### FINDLAY CITY PLANNING COMMISSION

### STAFF REPORT June 9, 2016

## SP-13-2016

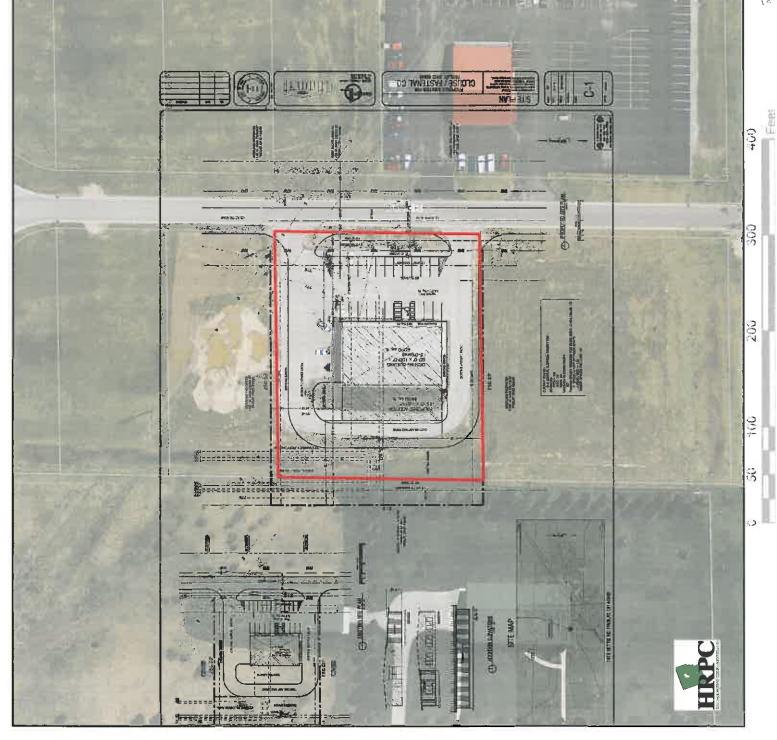
The applicant is proposing a 3,500 sf addition to the west side of the existing business. The addition will fit into an existing grass area and will not change the current accessibility or traffic patterns on site. The use stated in the application is product staging for shipping/receiving.

The addition matches up with the established building lines of the existing structure. It does not encroach into required rear yard setbacks.

The height of the addition is equal to the height of the lowest portion of the existing building. At 15' it is well below the maximum height permitted of 30'.

Facility is outside FFD's jurisdiction. After consulting with Liberty Twp. FD Chief Gene Stump, he requested the installation of a Knox box. Please consult with Chief Stump at 419-421-1087 for additional information.

Recommendations: Approval of the site plan.

## SP-14-2016

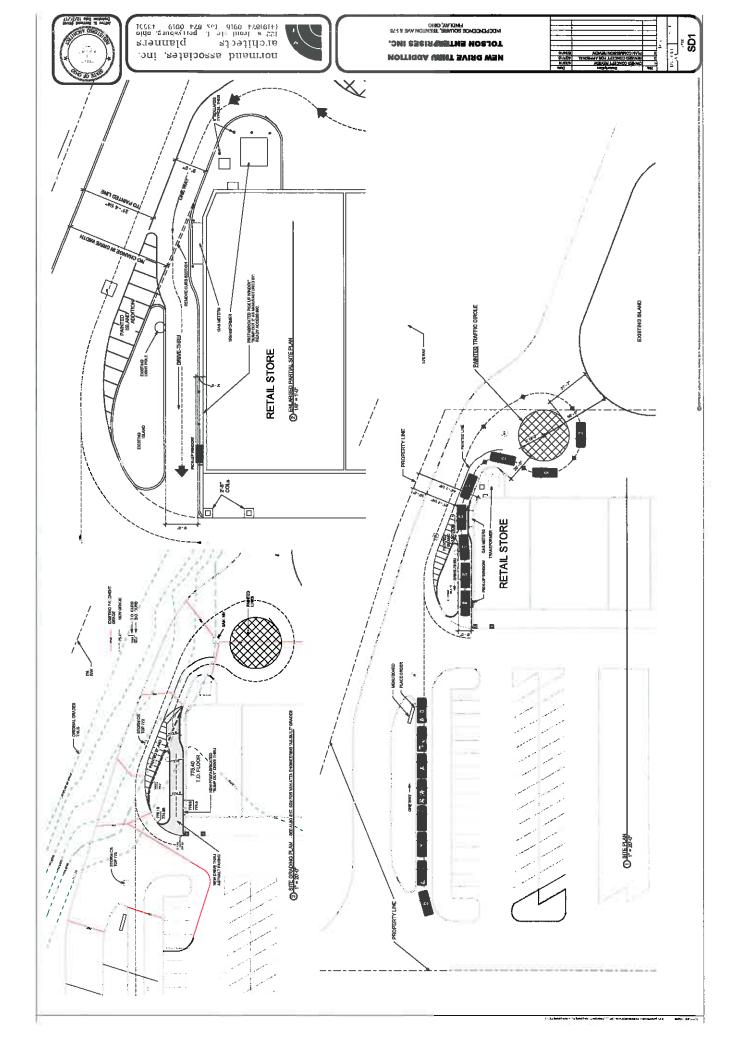
The layout proposes to use the location of a former ATM machine as the place for a menu board. This is located in an island along the east side of the parking lot directly north of the building. Cars would enter from the north, stop to order and then travel south across the east/west drive lane in front of the restaurant. They then continue south around the east side of the building and loop around on the south side of the building to pull up to the pick-up window. A portion of the area used to loop the cars in the rear of the building is off the lot belonging to the strip mall. There are cross access easements in place for this entire shopping area. Copies were submitted to HRPC with the application.

Staff sees the potential for many conflicts in the traffic pattern proposed. It will also be difficult to get potential customers directed through the shopping center site in general just to get in the correct location to order.

The cars will enter the existing lane that was installed in the past for an atm machine to pull up to the menu board and order. Once they order, the driver will need to drive to the rear of the strip mall where they will go around a painted traffic circle and will enter the pickup lane (located along the side of the existing structure) and will pull up to the pickup window.

Engineering feels that the proposed traffic pattern will be confusing to the public and is not sure how the proposed route could be signed to eliminate the confusion. After they order, the drivers will also have to contend with any traffic driving in front of the strip mall or around the side of the strip mall and will more than likely try to make the sharp turn into the pickup lane instead of using the proposed traffic circle.

Recommendations: Engineering recommends denial of the site plan due to the proposed traffic pattern being confusing and the potential conflict points that it creates with vehicular traffic.

# PP-03-2016

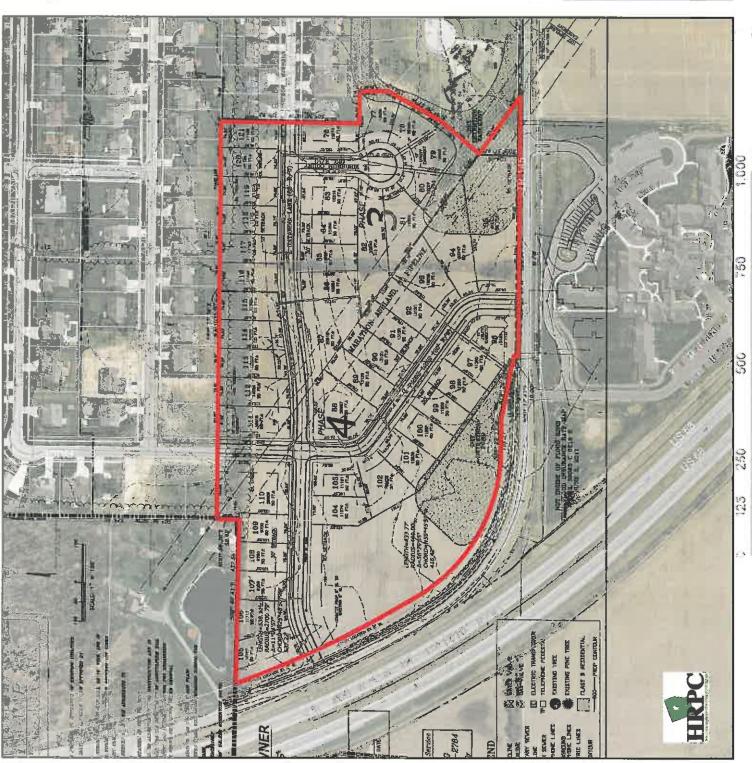
There are 46 new lots proposed. Lots 107-109 on the north side of Katarina Lane and west of Paige Lane in Phase 4 will need to be adjusted to meet current minimum standards of 10,000 square feet. Section 1111.04 (a) (5) of the City Subdivision Regulations state that excessive lot depth to width ratio shall be avoided. A depth to width ration of 3 to 1 shall normally be considered a maximum. If the lots cannot be adjusted to comply, a variance from CPC will need to be obtained.

There is a large remainder lot located along the curve of the road on the west side which should be labelled with some lot number or letter.

- Adjust Lots 107-109 in Phase 4 to be a minimum of 10,000 square feet (HRPC)
- Label Lot along the curve with the Detention pond (HRPC)
- Reconfigure Lots 82, 94 and 95 or obtain a variance from CPC (HRPC)
